Technical Service Information

THM 4L60-E

NEW PARK/NEUTRAL BACK-UP FOR ALL 2004 MODELS

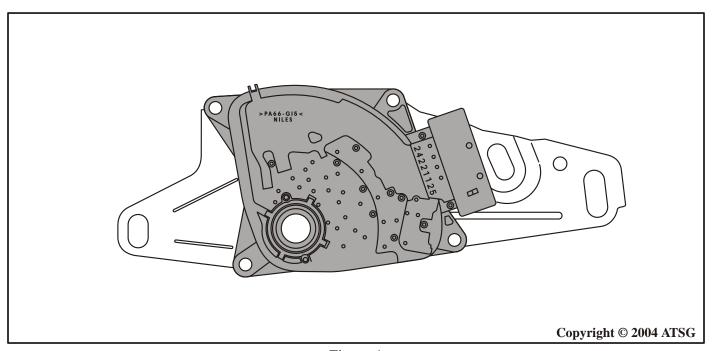
- (1) PARK/NEUTRAL BACK-UP SWITCH Now has only one connector instead of the previous two connector switch, as shown in Figure 2.
- (2) PARK/NEUTRAL BACK-UP SWITCH CONNECTOR Revised vehicle harness connector to accommodate the revised PNBU Switch, as shown in Figure 2.

Figure 2
AUTOMATIC TRANSMISSION SERVICE GROUP

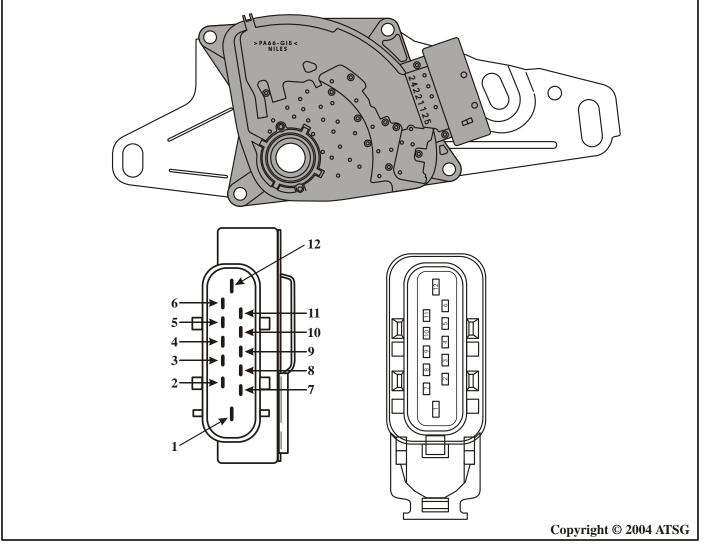
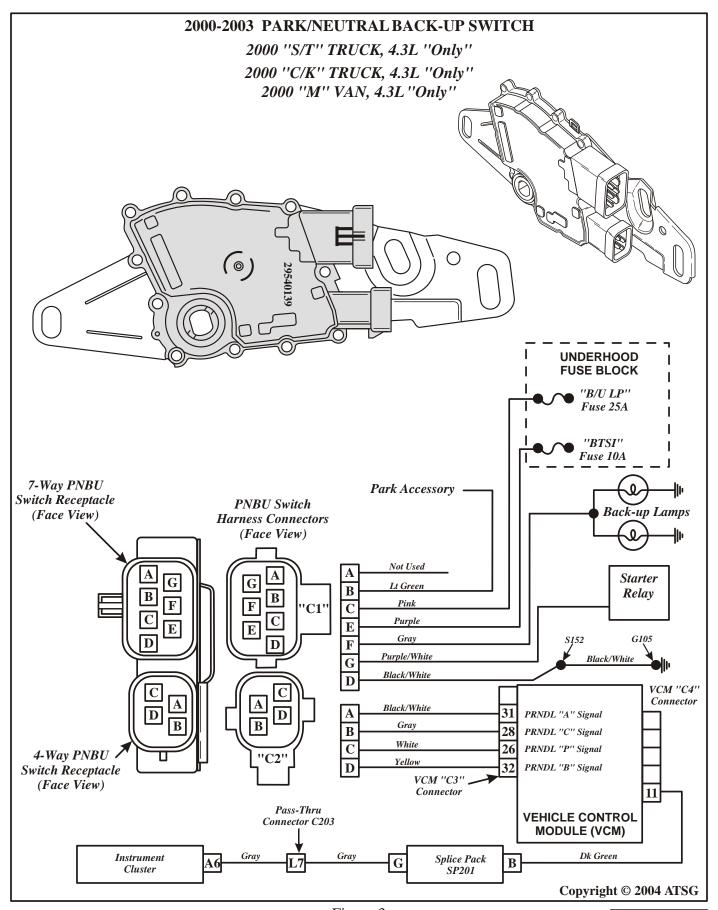
CHANGE: Beginning at the start of production for 2004 models, equipped with the THM 4L60-E

transmission, a revised Park/Neutral Back-Up (PNBU) switch was implemented with one 12 pin connector instead of the previous two connectors (See Figure 2). 2000-2003 models are shown

in Figure 3.

Will not interchange with any previous models.

Park/Neutral Switch (1996-2003 Models)	29540479
Park/Neutral Switch (2004-Up Models)	24221125
